Title CH-012 Transistor Curve Tracer Adapter for OSC		
Size B	Number http://www.thaikit.com	Revision 1.00
Date: 13-Dec-2013	Sheet of 1	
File: D:\CH-012.DDB	Drawn By:

Engineer Change Notice

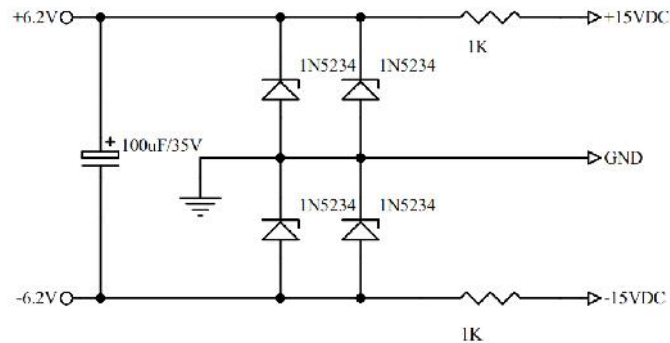
1. There are 2 options for 6.2V Zener diode.

1.1 In case, the kit has 4x 1N5234 which is 500mW, please install all 4 units.

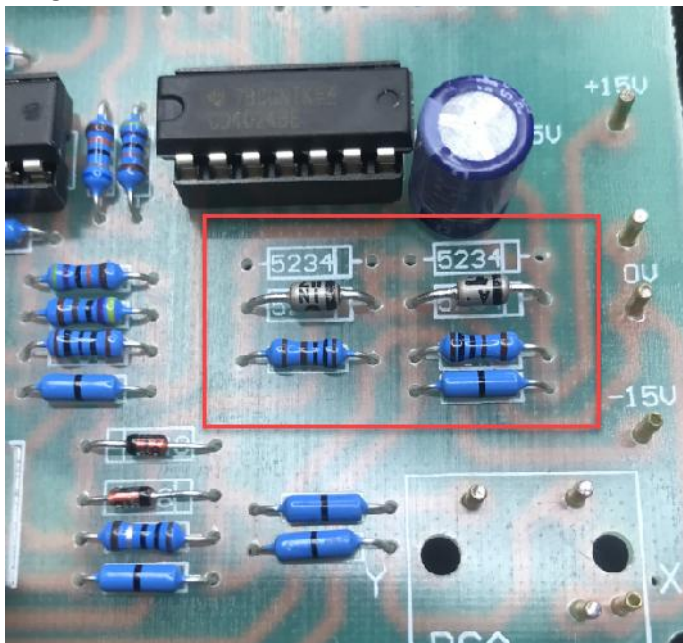
1.2 In case, the kit has 2 x 1N4735 which is 1W, please install only 2 units. Please refer to the image.
